## Mask Set Errata

MSE908AS60\_3J74Y  
12/2002

Mask Set Errata for 908AS60,  
Mask 3J74Y

### CHxMAX — Channel x Maximum Duty Cycle Bit

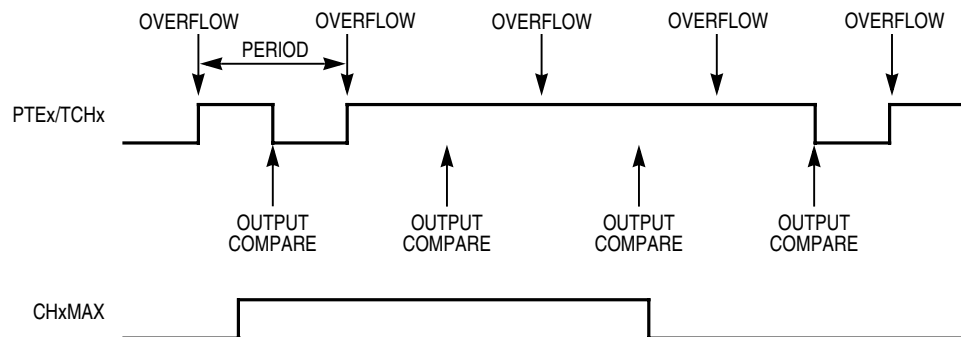
The PWM 100% duty cycle is defined as output high all of the time. To generate the 100% duty cycle, use the CHxMAX bit in the TSCx register.

When the TOVx is at logic 1 and clear output on compare is selected, setting the CHxMAX bit forces the duty cycle of buffered and unbuffered PWM signals to 100%. As this figure shows, the CHxMAX bit takes effect in the cycle after it is set or cleared. The output stays at 100% duty cycle level until the cycle after CHxMAX is cleared.

**NOTE:** The PWM 0% duty cycle is defined as output low all of the time. To generate the 0% duty cycle, select clear output on compare and then clear the TOVx bit (CHxMAX=0).
